NSW Independent  
Planning  
Commission

Pitt Street South  
OSD

INTERNAL AMENITY  
SUBMISSION

18 March 2021  
Final

### Proposed:

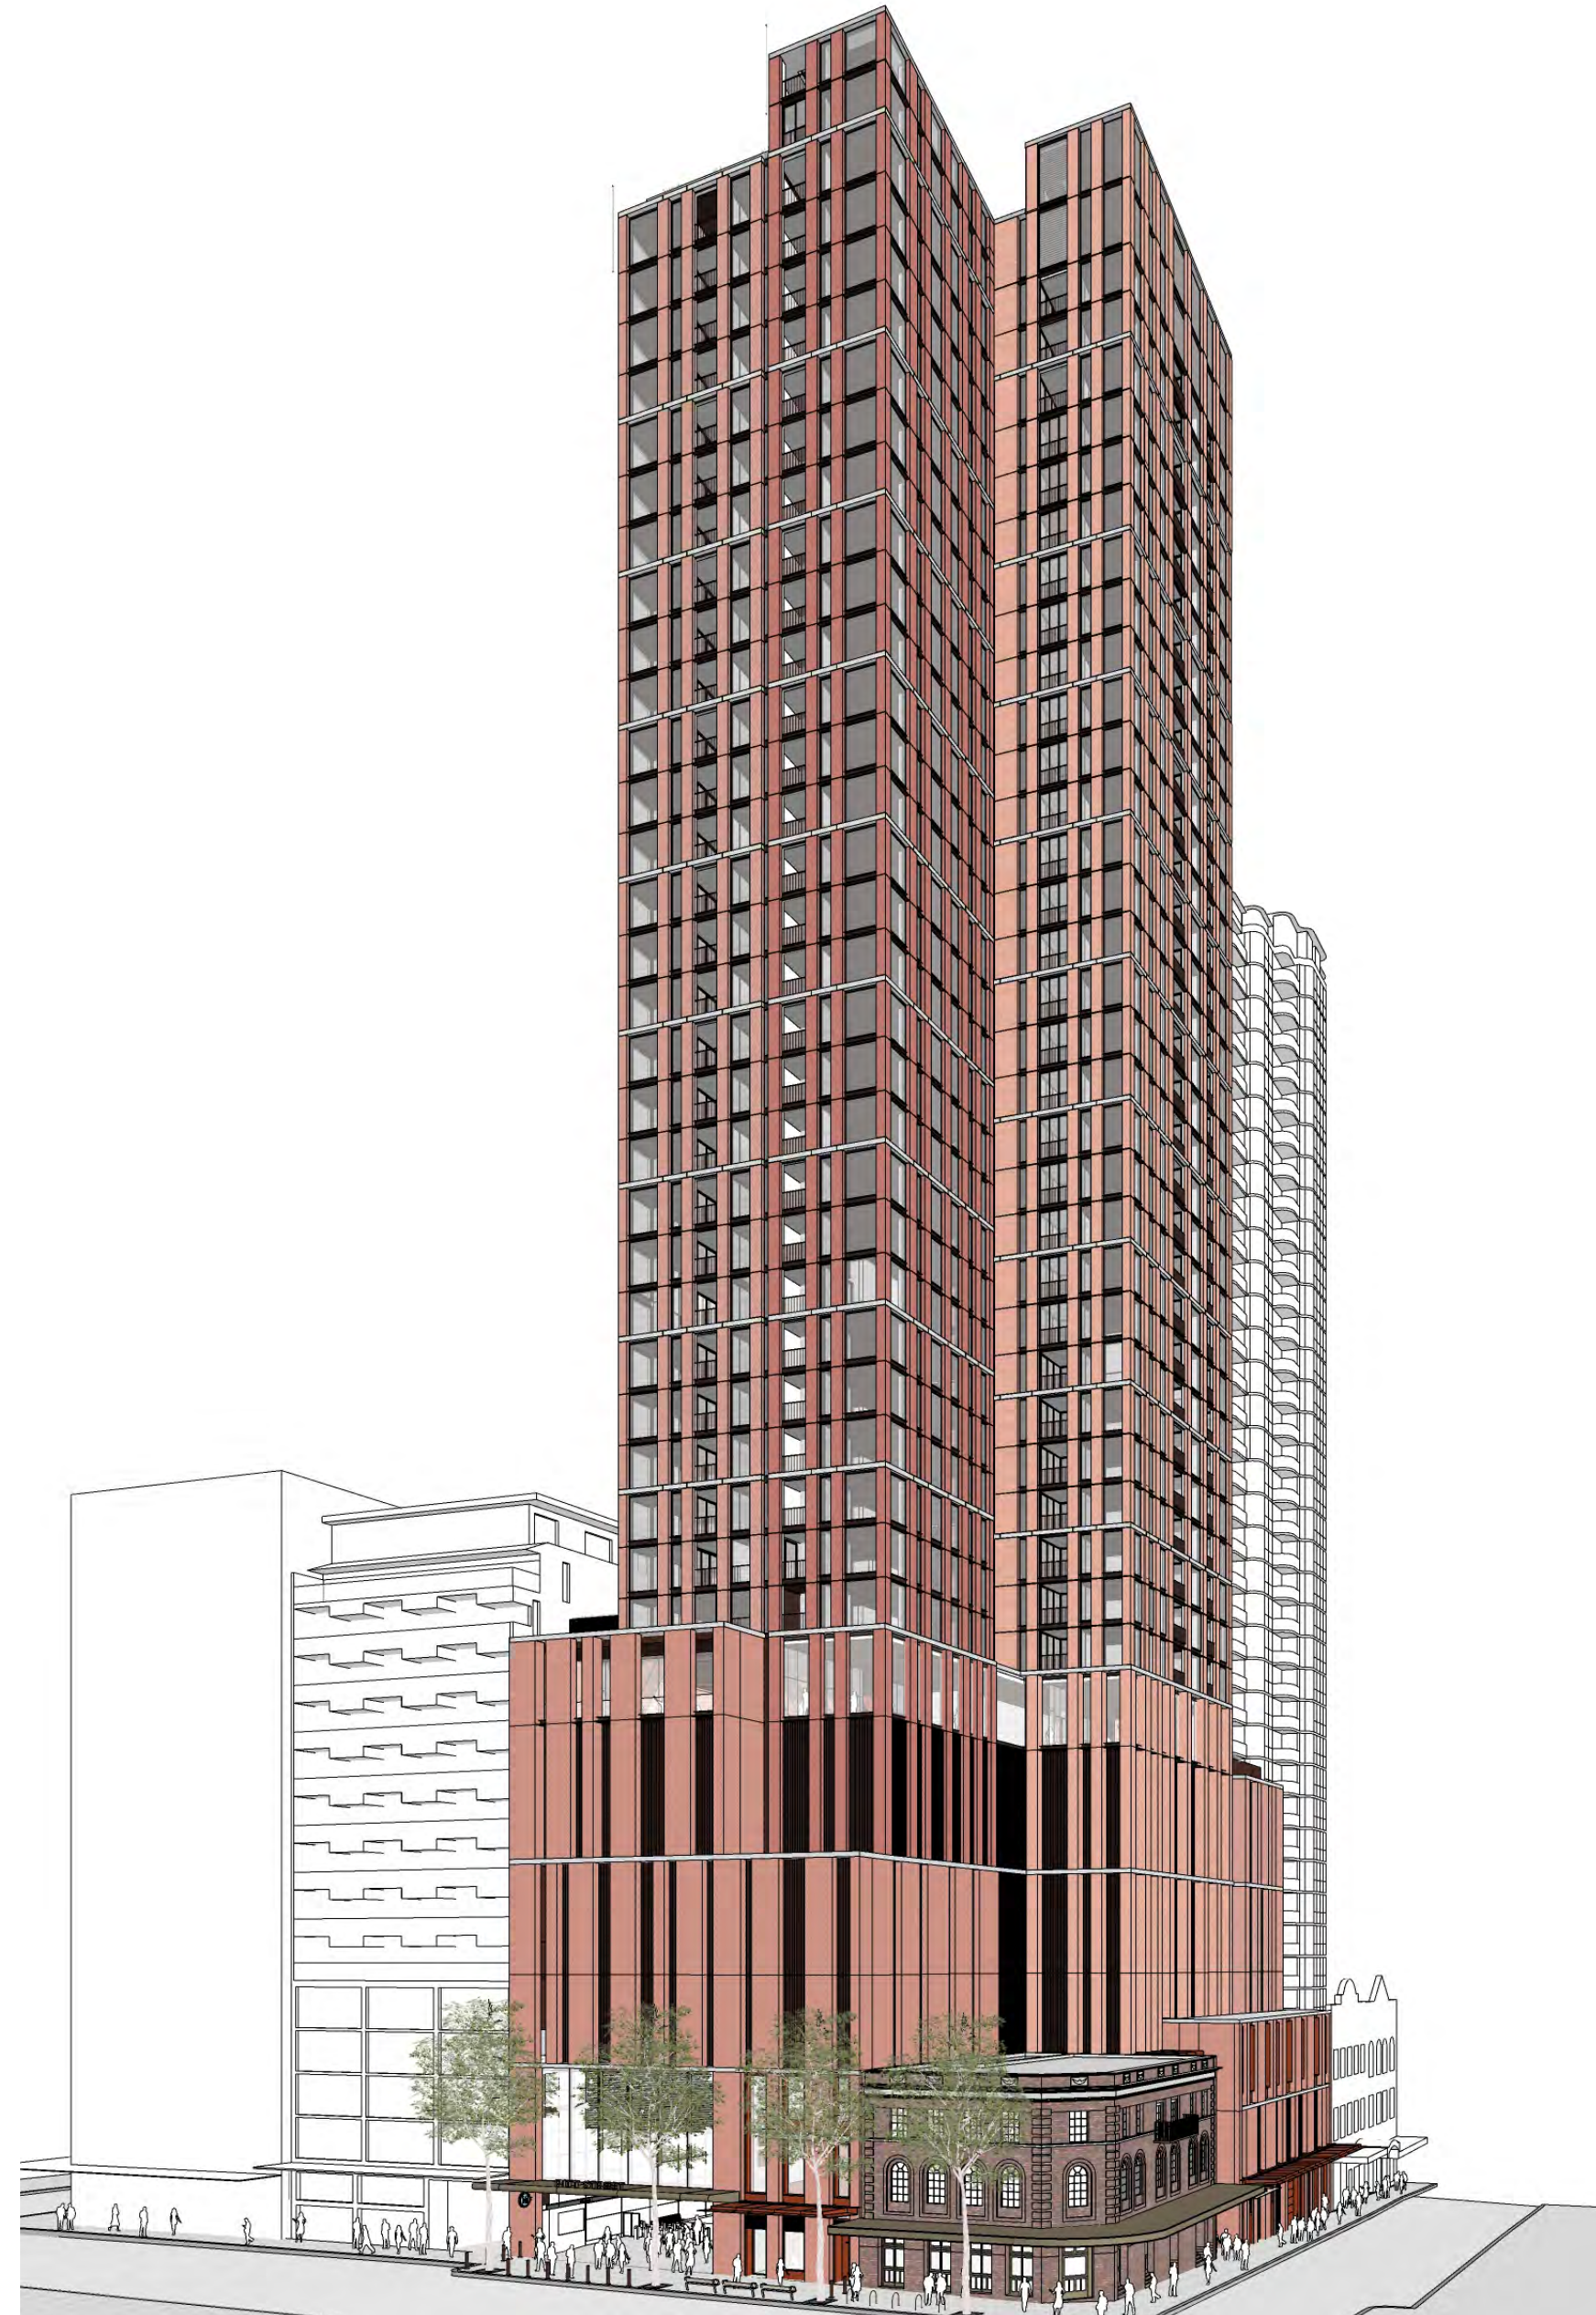
- The majority of these change were rejected by the Panel, “The Panel reasserts its earlier assessment that the minor encroachments outside the building envelope create no adverse impacts on privacy and solar access. Whilst the Panel applauds the project teams’ efforts to reduce these encroachments, the Panel believes the reduced depth to the GRC facade elements diminishes the architectural quality of the facade, and should be calibrated to the building orientation (e.g. maintaining the deeper panels on east/west)”

*Review the appropriateness of the proposed projections beyond the approved building envelope with respect to any additional impacts when compared to a complying development, including further consideration of any:*

- \* overshadowing impacts to adjoining residential properties*
- \* privacy and visual impacts resulting from further encroachments on minimum building separations*
- \* streetscape impacts*
- \* ongoing maintenance of boundary conditions.*

- DD on GRC from 450 x 800/900 to 250x 900*
- Reduce depth to comply with town planning envelope*
- Improved consistency of width (800 v's 900)*
- Increased solar access to living rooms*
- Refined locations to create regularised proportions relating to internal rooms*

- 450mmD x 800mmW GRC

- 250mmD x 800mmW GRC
- 200mm reduction in depth

- 450mmD x 800mmW GRC

- 250mmD x 800mmW GRC
- 200mm reduction in depth

1:1 Scale Plan  
400mm x 800mm GRC facade

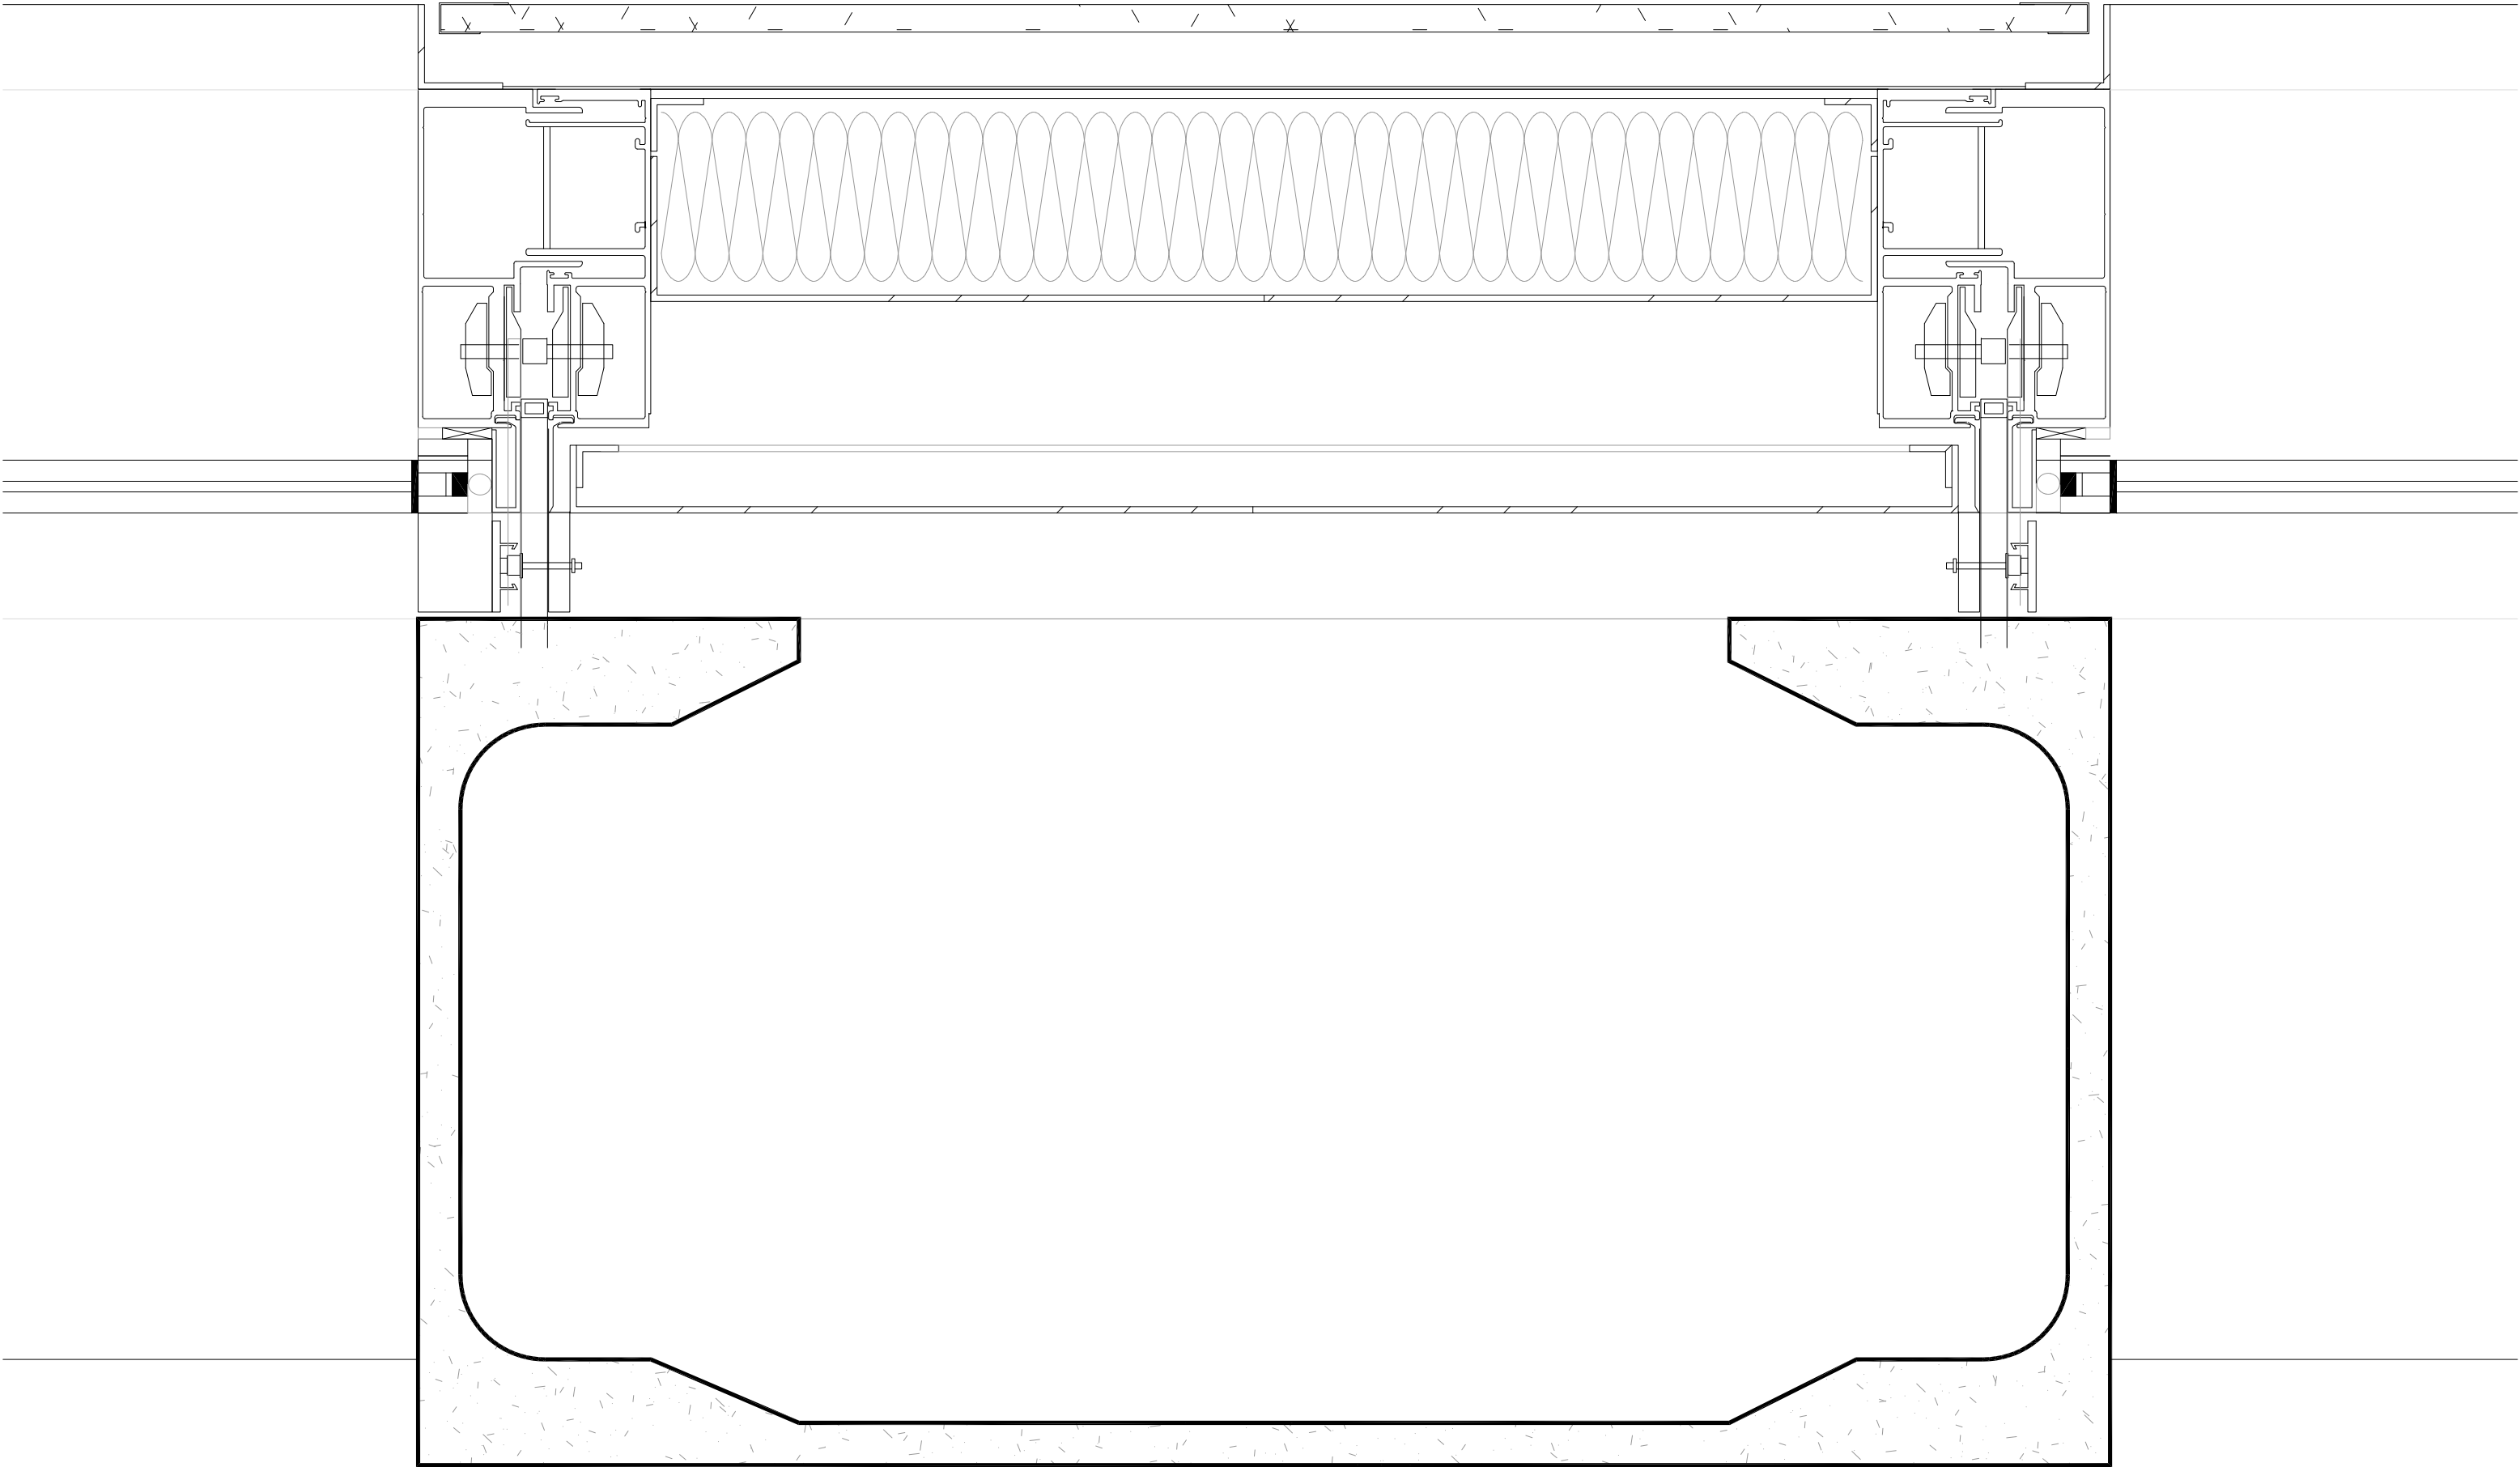
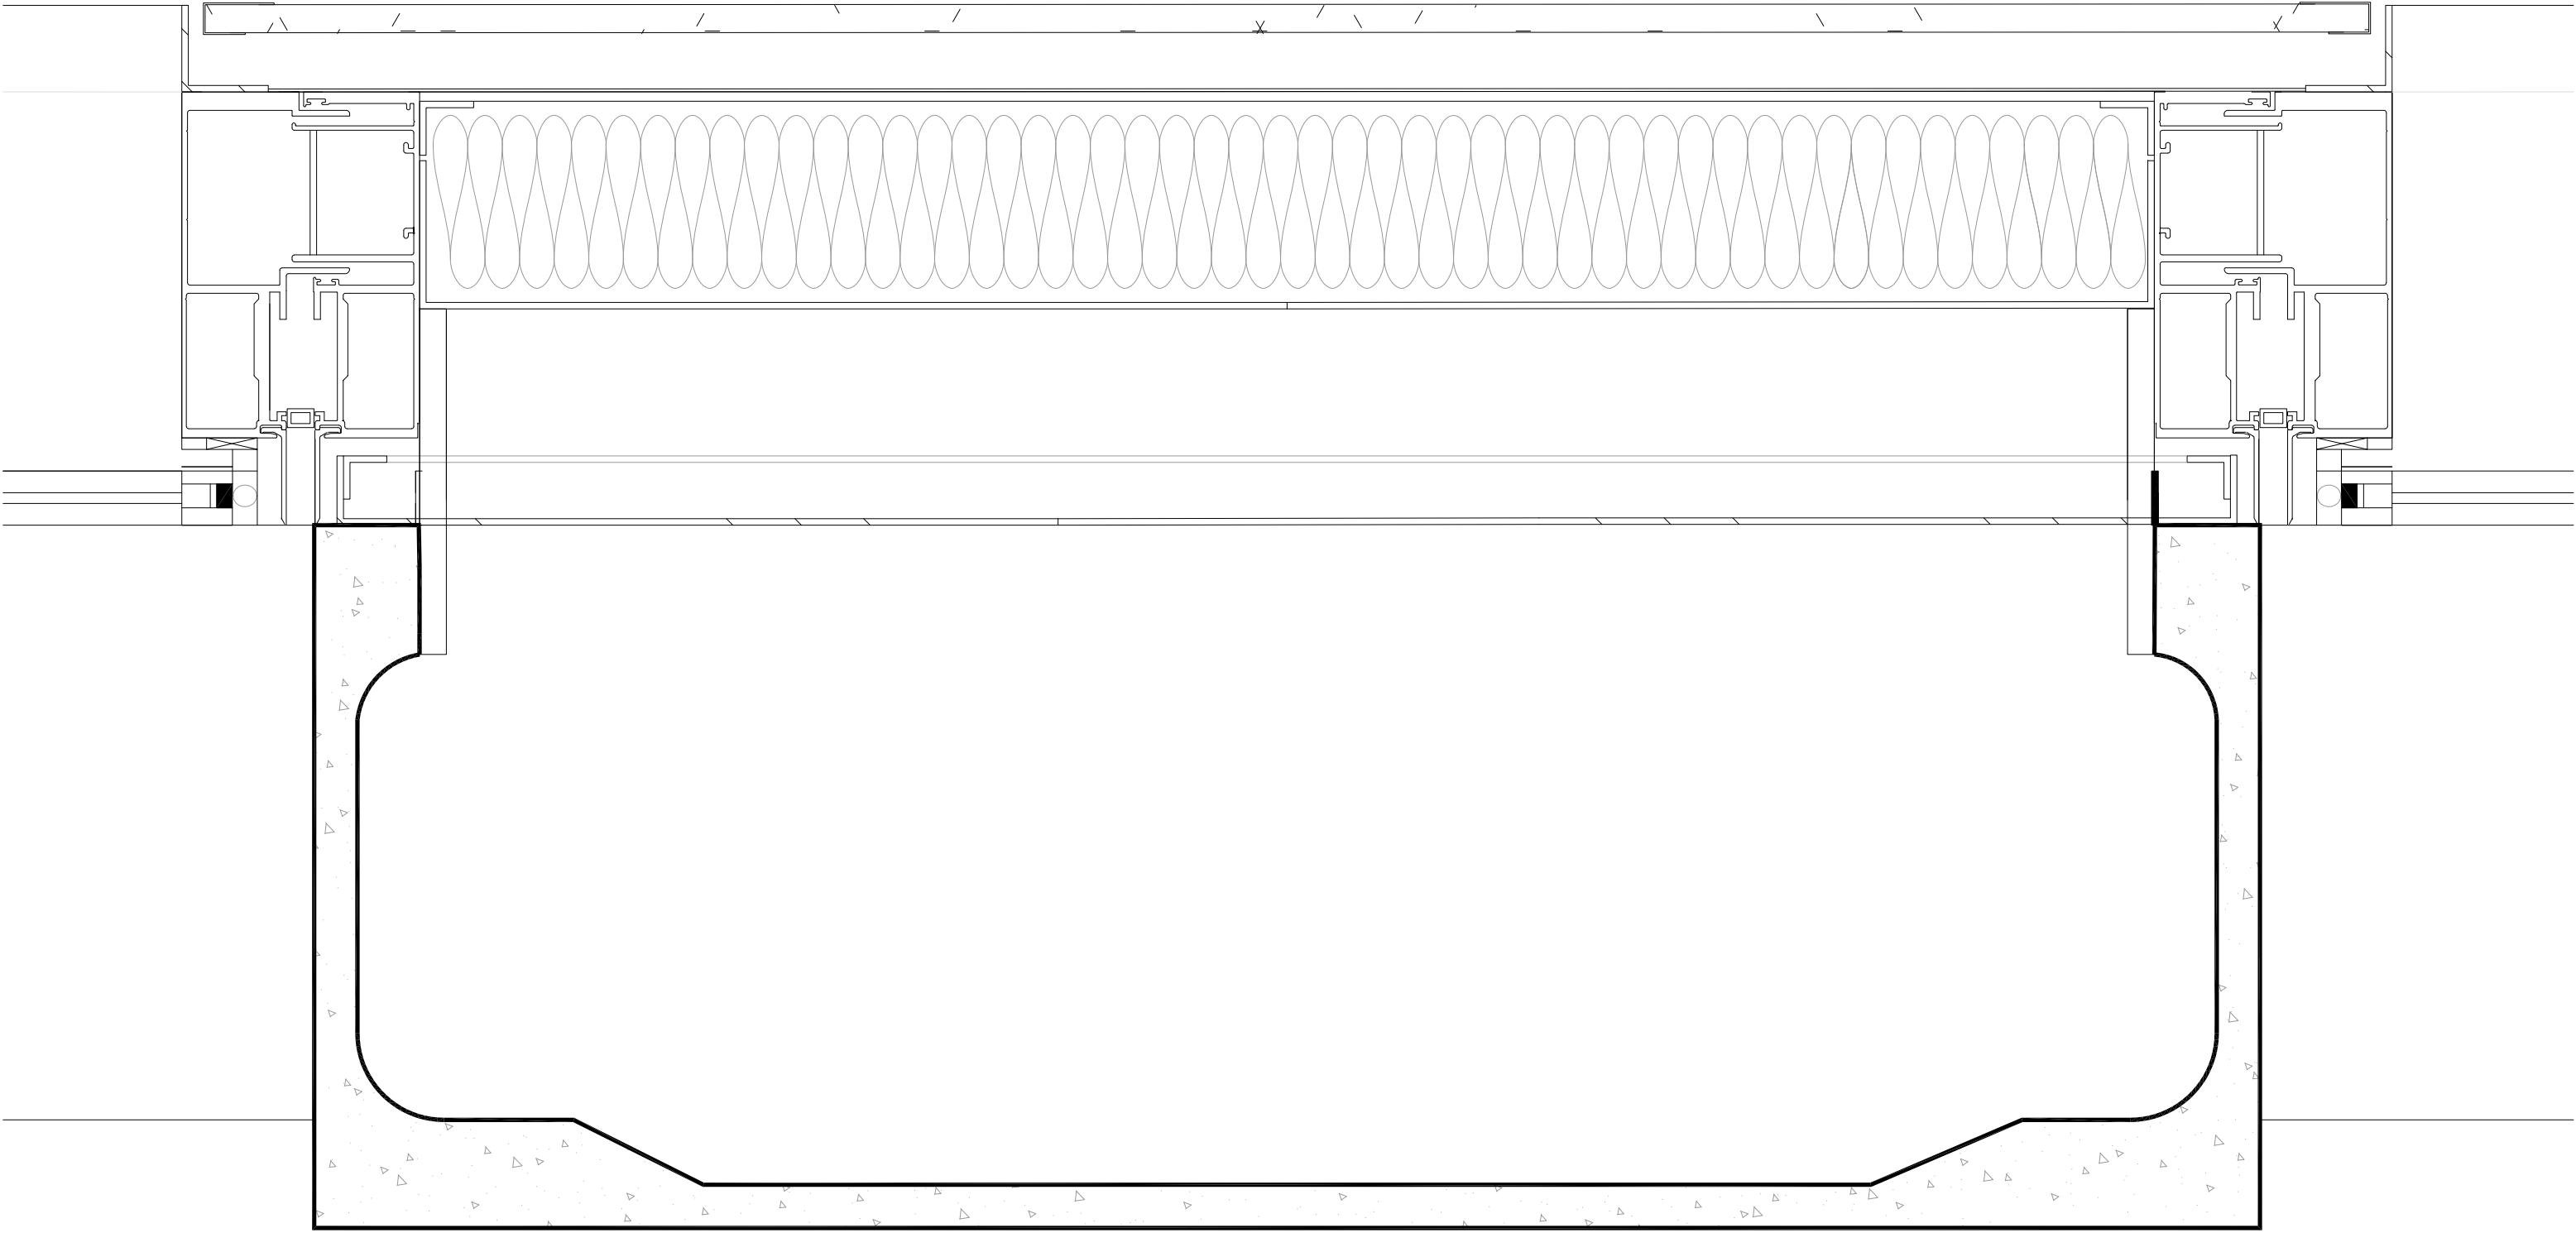
- DRP 13 Supplementary 1 was a single issue DRP focusing again on the GRC elements, specifically the physical dimensions when viewed in 1:1 scale
- This represented a regression from the previous DRP, “Following review....the Panel does not support the reduction in depth of the GRC unit....and recommends the original depth of 450mm to the glass line be maintained. The Panel supports the change in width of the GRC units to 900mm”

- The DRP went on to comment, “The Panel notes that there has been a significant reduction in the quantity of GRC units in the facade from the initial Stage 2 DA to that which is currently proposed as part of the Response to Submissions. This reduction appears to have increased beyond that which was presented to the DRP on the 18th August. The reduction of quantity of solid elements on the facade is impacting design excellence – i.e. the overall appearance and integrity of the design, in addition to a potential increase in solar load on the building. The Panel requests an urgent comparative analysis (of % of solid vs glazing) is provided of the Stage 2 DA facade vs the current proposed facade, prior to resubmission – in order to ascertain the overall impact”

- The revised standardized dimension of 325mm x 900mm now allows all façade elements to achieve a constant 'visual mass' of 1.235m, greater than that of almost all of the previous façade elements. Thus we:

a) Are confident that the degree of solidity expressed by the revised façade elements will not 'erode' the degree of solidity in the façade, but

b) We prefer the improved rigour of the façade design now all consisting of elements of the same width, and

c) We also prefer the proportion of the 900 x 325 deep elements as being closer to 1:3 than the earlier relationship of 800 x 400 which was less elegant at 1:2.
